## MODIFICATIONS: **BLAST CHILLERS**

COMMERCIAL REFRIGERATION

## Modification of the refrigeration unit

## Previous design

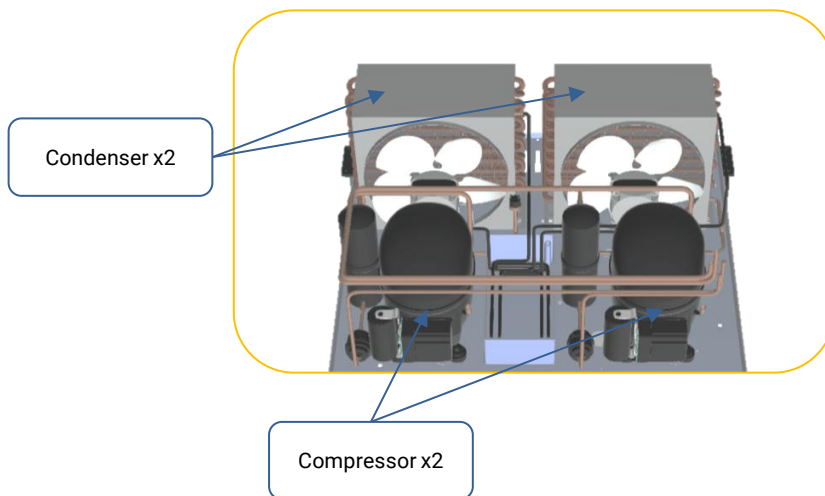
A more efficient solution is being introduced: two refrigeration units are replaced by a single, more powerful system.

Evaporator with two independent circuits:

Evaporator with one circuit:
